SUNDRY NOTICES AND REPORTS ON WELLS
Do not use this form for proposals to drill or to re-enter an abandoned well. Use Form 3160-3 (APD) for such proposals.

| 2. Name of Operator Vanguard Operating, LLC | 8. Well Name and No. Doris Federal #3 |

Doris Federal 3
30-005-61004
Vanguard Operating, LLC
October 16, 2018
Conditions of Approval

AFTER PTA

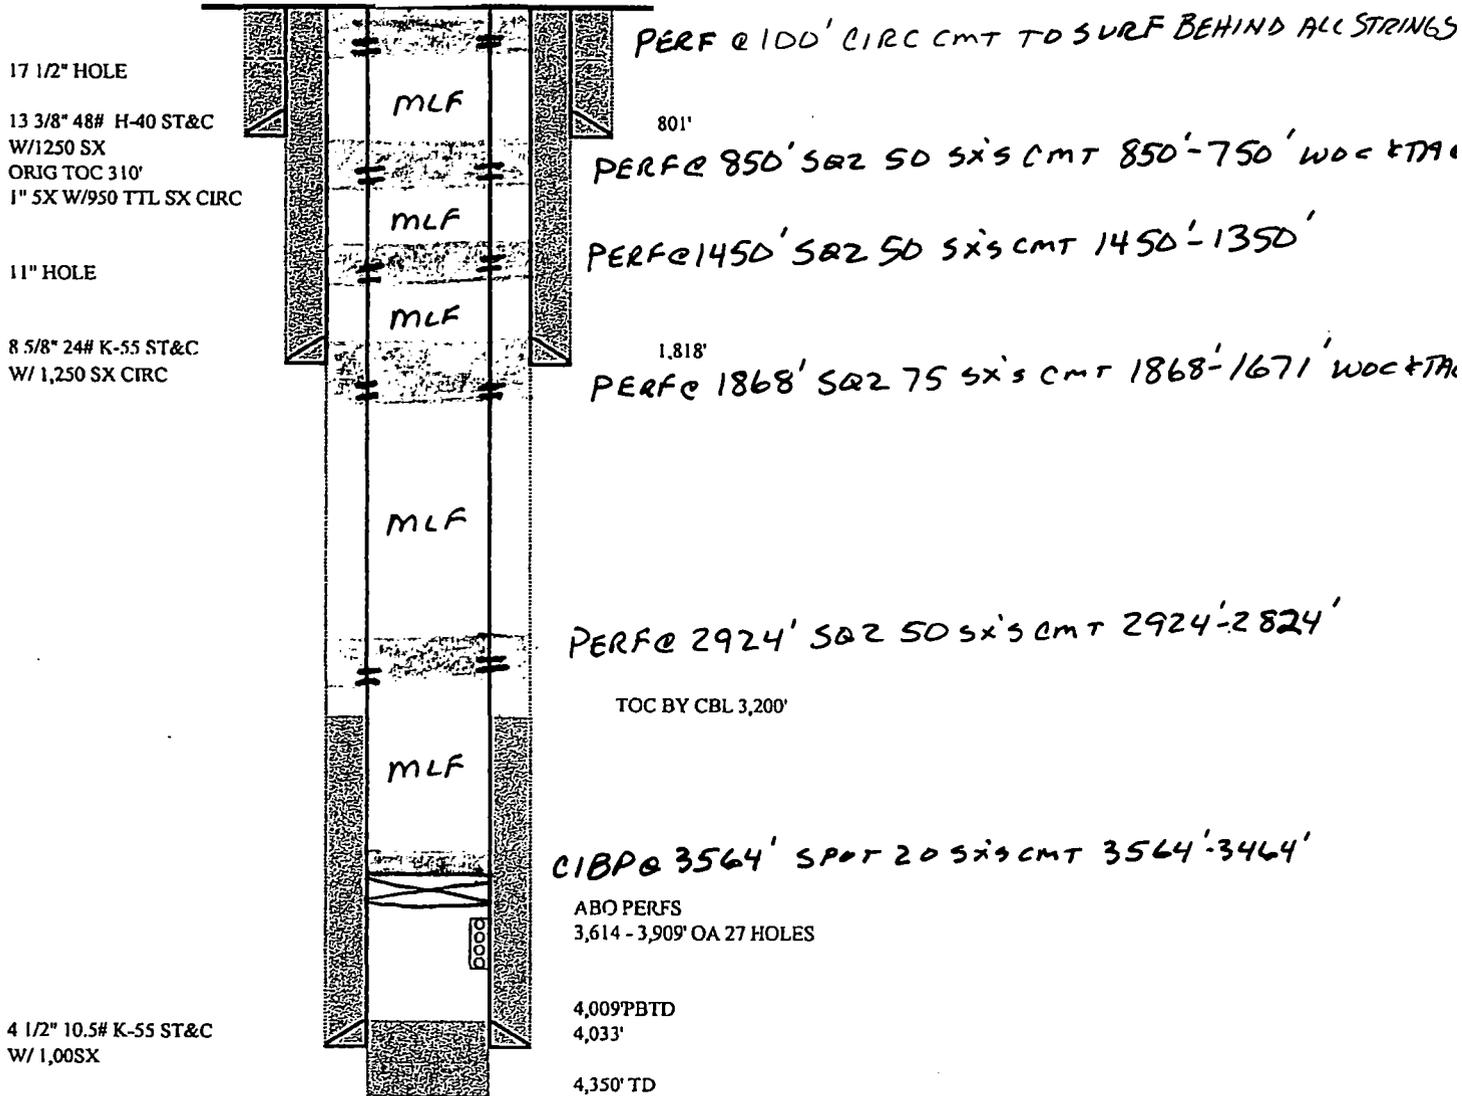
- 1. Operator shall place CIBP 50'-100' above top most perf and place 25 sx of Class C cement on top to seal the Abo Formation. WOC and TAG.**
- 2. Operator shall perf at 2,924' and squeeze cement as proposed. Operator shall place a Class C cement plug from 2,924'-2,824' as proposed. WOC and TAG.**

- 3. Operator shall perf at 1,868' and squeeze cement as proposed. Operator shall place a Class C cement plug from 1,868'-1,671' as proposed to seal the 8-5/8" shoe. WOC and TAG.**

- 4. Operator shall perf at 1,500' and squeeze cement as proposed. Operator shall place a Class C cement plug from 1,500'-1,350' as proposed to seal the Glorietta Formation. WOC and TAG.**

- 5. Operator shall perf at 850' and squeeze cement as proposed. Operator shall place a Class C cement plug from 850'-750' as proposed to seal the 13-3/8" shoe. WOC and TAG.**

- 6. Operator shall perf and squeeze at 100'. Operator shall place a Class C cement plug from 100' to surface as proposed.**
- 7. See Attached for general plugging stipulations.**
